**Engineering Report
For the
Proposed Dodge County Drainage District No. 88
Submitted to the
Dodge County Drainage Board
By the
Wisconsin Department of Agriculture, Trade, and Consumer Protection
September 24, 2010**

**Dodge County
Town of Burnett
Proposed Drainage District No. 88**

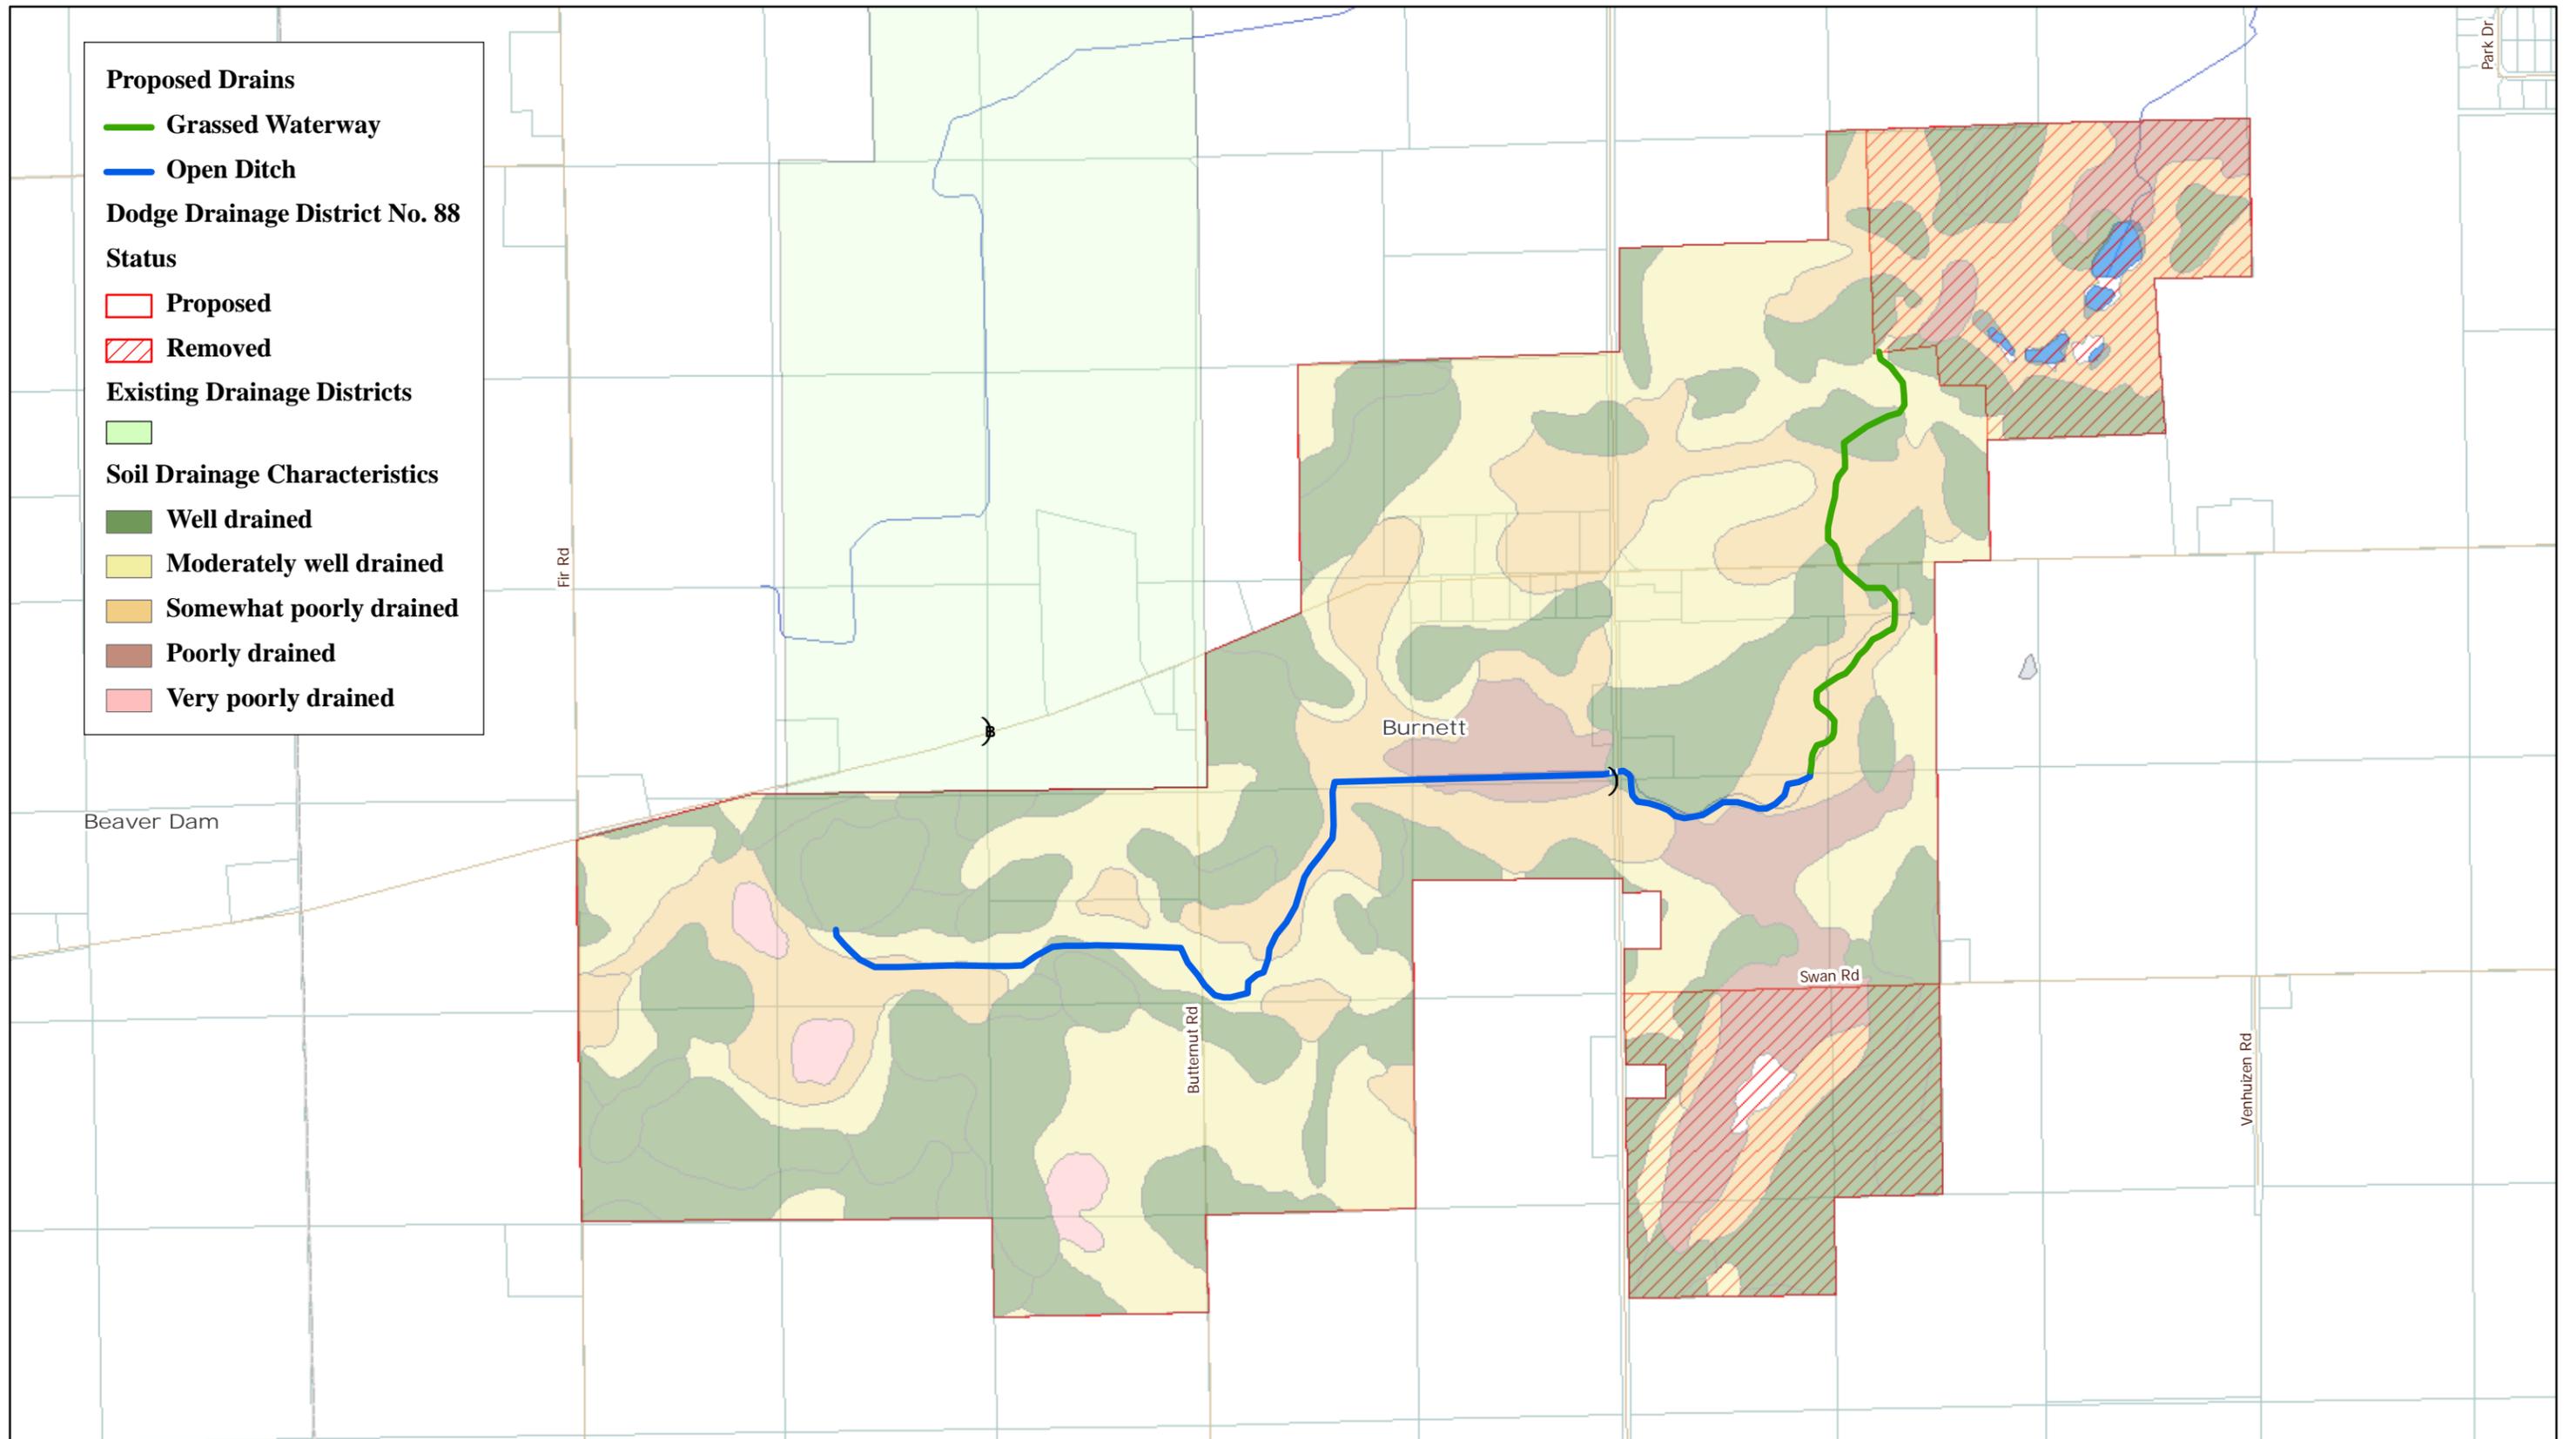
From the video footage provided by Mr. Giese and an examination of the lands and drainageways upstream it seems that the majority of the sediment that has been deposited in the Giese ponds have come from the field belonging to John Meylink immediately adjacent to the Giese property. At one time there had been a grassed waterway through the Meylink's land; it has since been replanted with soybeans. Early spring runoff has entrained a large amount of soil, most likely laden with phosphorous, sending that sediment to the Giese's ponds.

The proposed drainage district would restore the grassed waterway through the Meylink's land, greatly reducing the amount of soil exported from the field and trapping other sediment transported from further upstream. A perennial grassed waterway would be especially beneficial in spring before crops have become established to effectively stabilize the soil.

In addition, the drainage board could take more actions to further reduce the amount of sediment and phosphorus transported downstream. ATCP 48.30(2) states that "A county drainage board shall design, construct, and maintain district drains and corridors to minimize soil erosion and the movement of suspended solids into district drains." Under ATCP 48.24, Wis. Admin. Code, the Drainage Board has the ability to regulate the planning of crops within a maintenance corridor on either side of its drainage facilities in order to "provide a buffer against land uses which may adversely affect water quality in the district ditch." The drainage board could establish vegetated buffer strips in those corridors. Buffer strips have been shown to greatly reduce the amount of nutrient transport to downstream waterways.
